RE: **Approval of Plans (REV 1)**
TDOT Gibson County Maintenance Building
1248 B Manufacturers Row
Trenton, TN 38382

TFM # 21267
Project # 2023-11-09-02
County: Gibson

Revision #1 Drawing Changes

M1.0

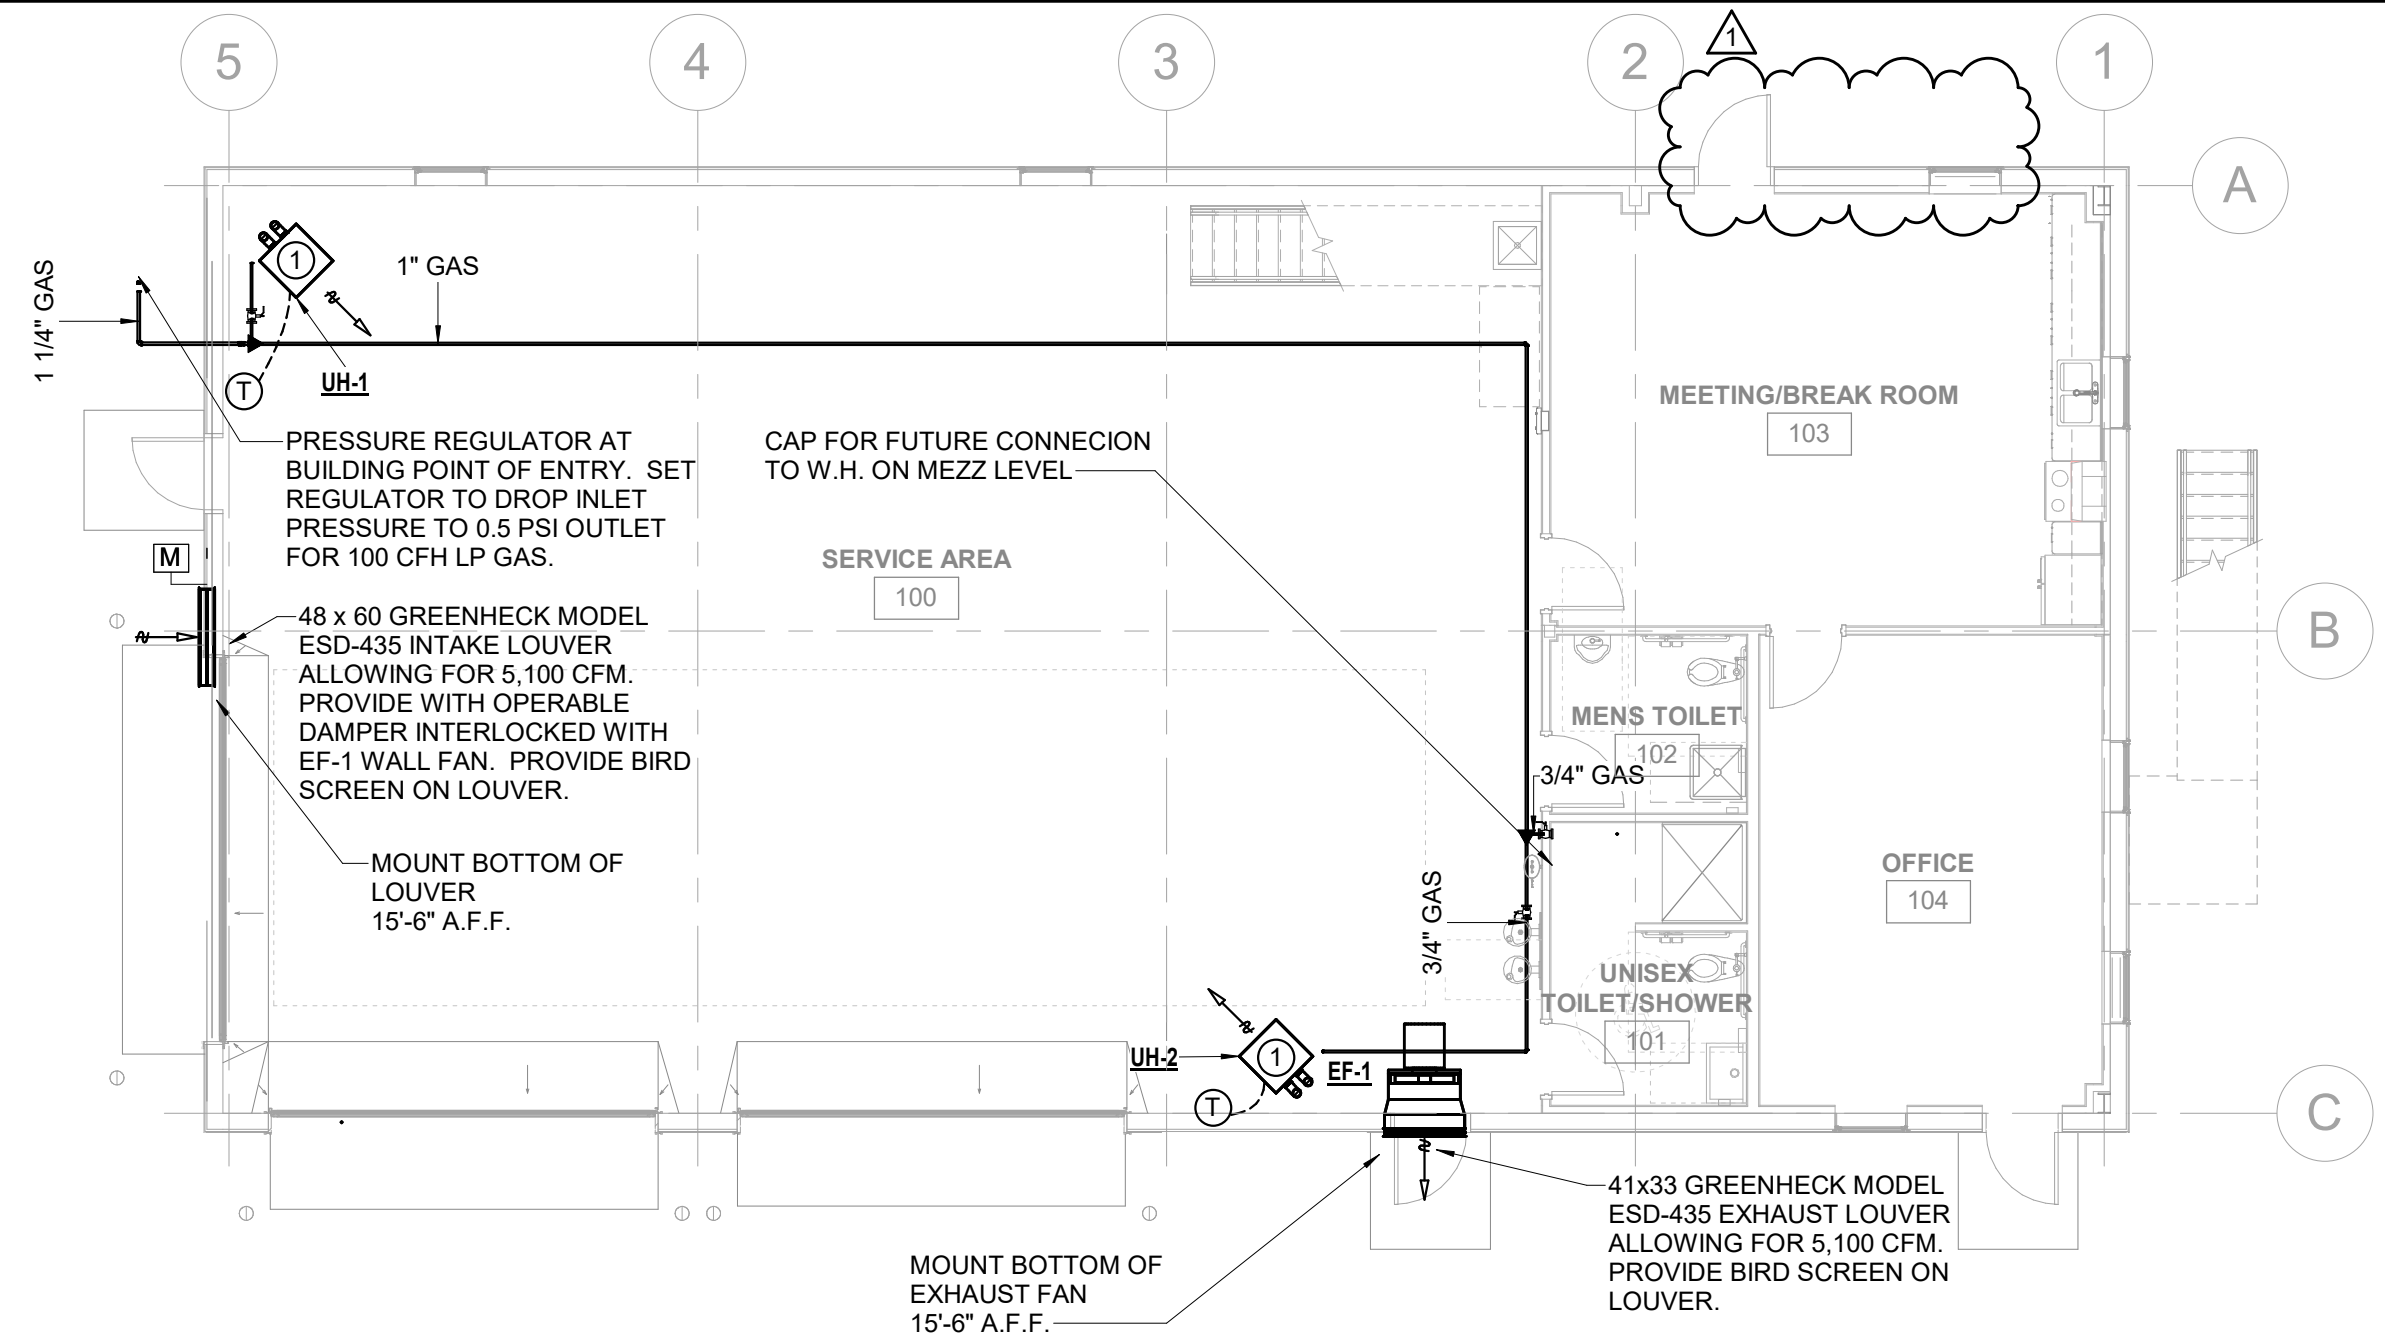
Sheet M1.0: Revised location of exterior door.

1 PLUMBING PLAN - LEVEL 1 CORE AND SHELL

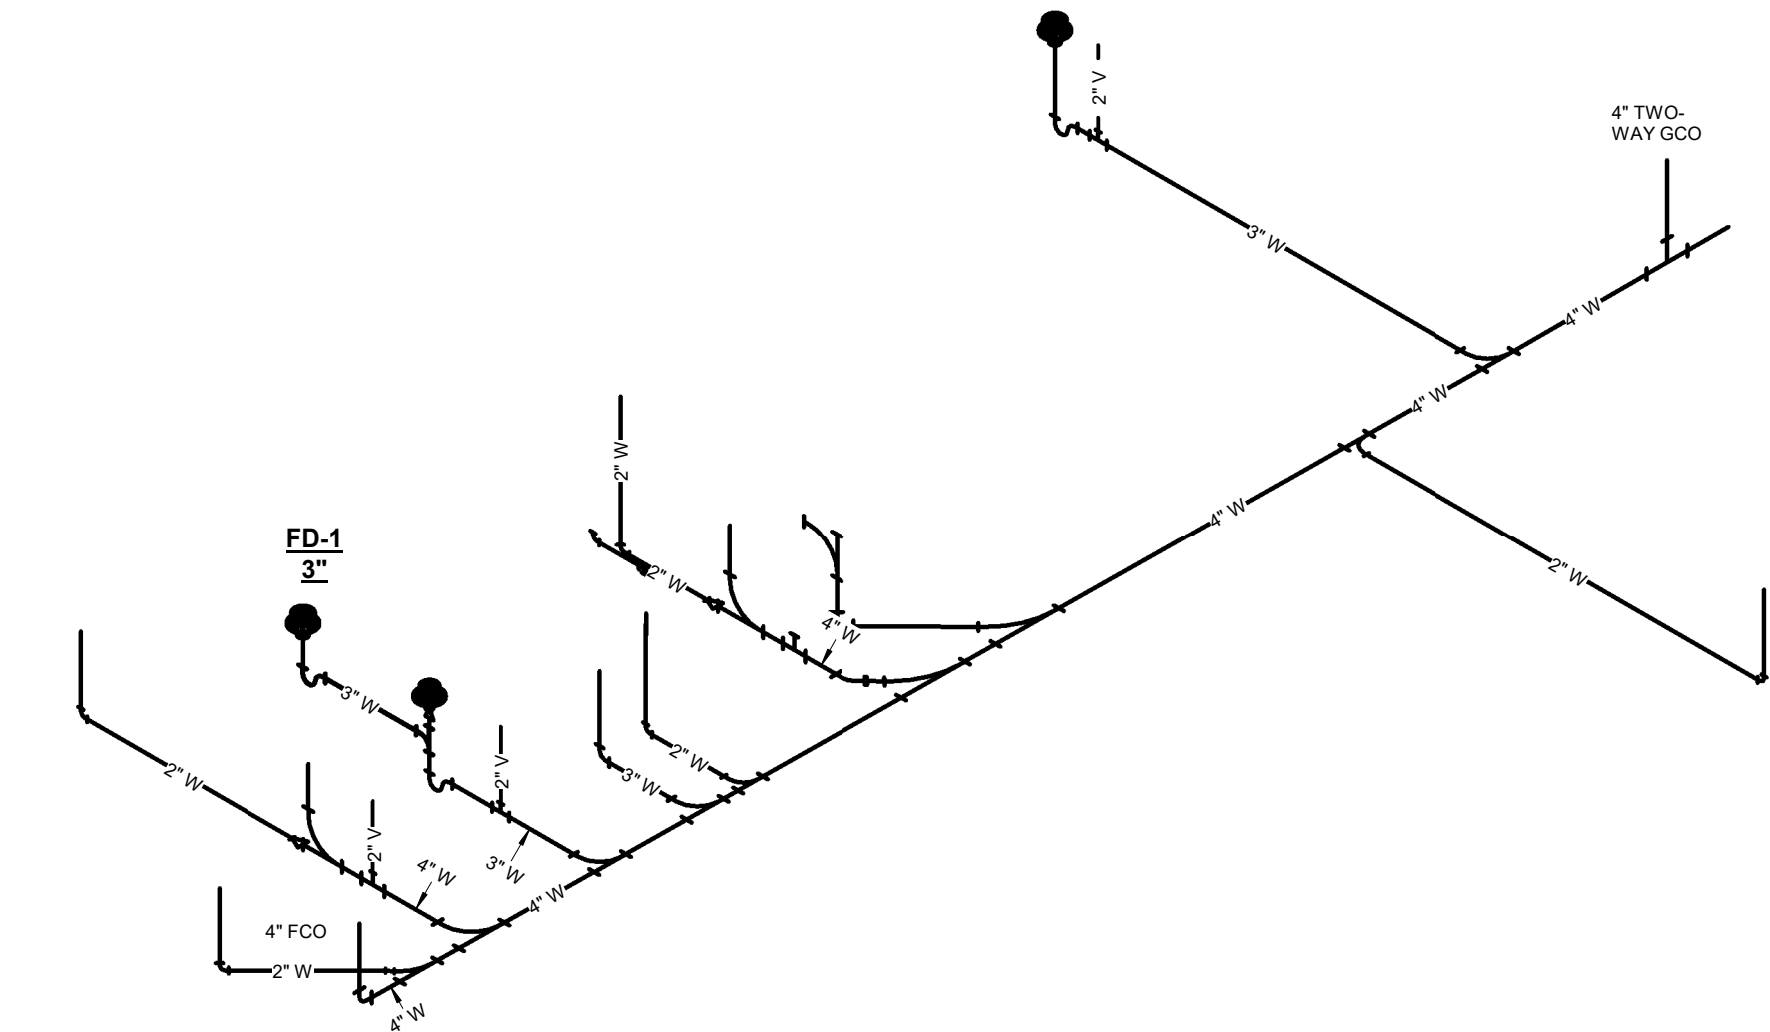
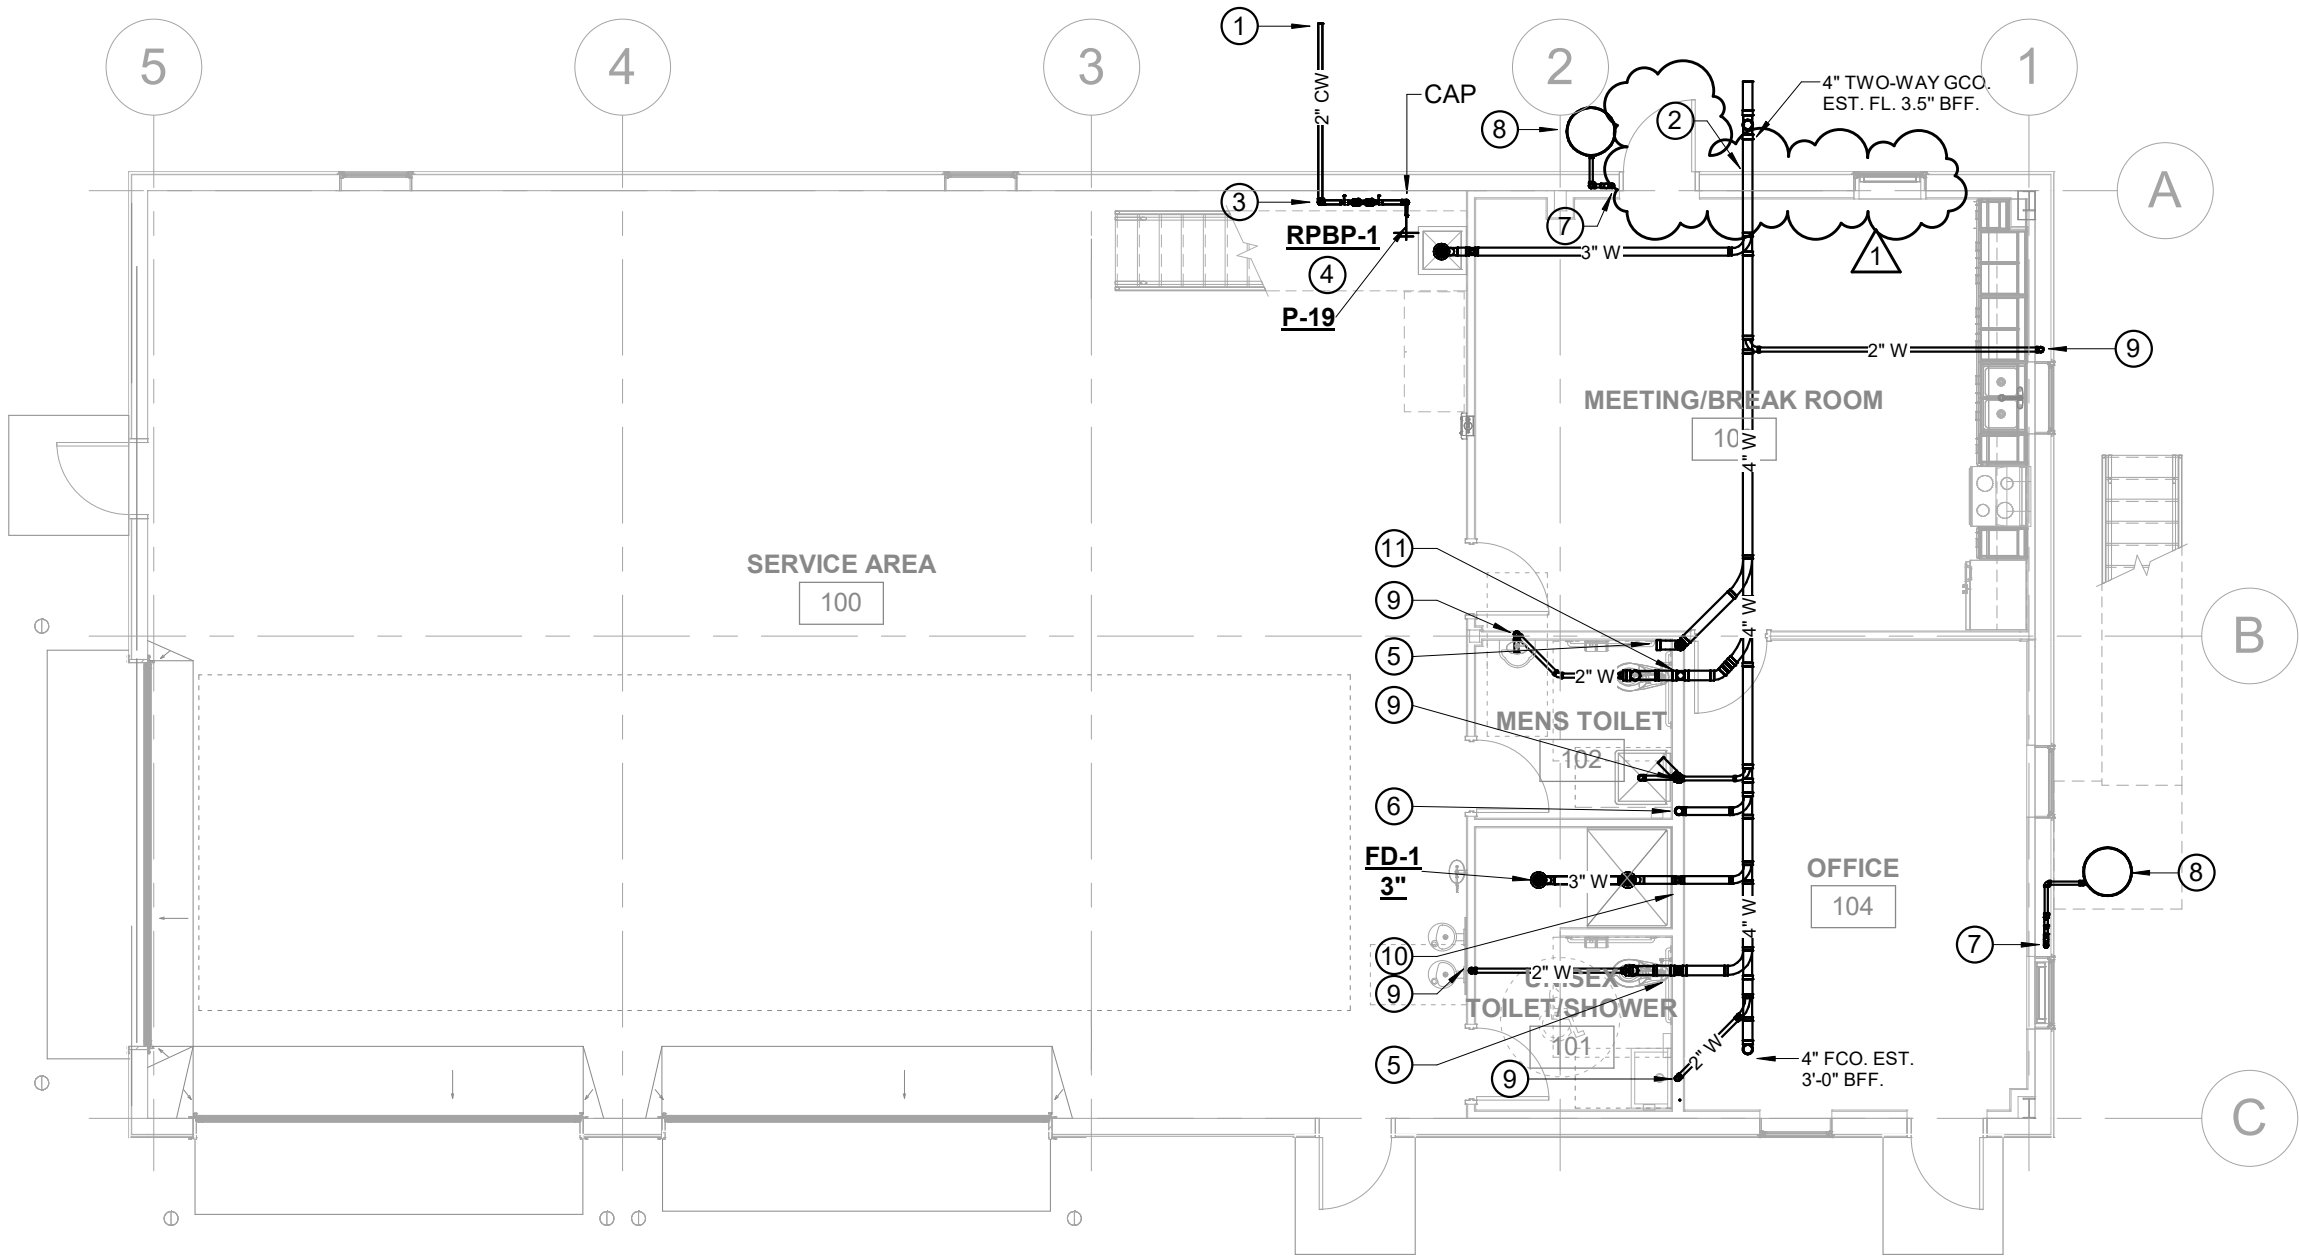
Sheet P1.0: Revised location of exterior door.
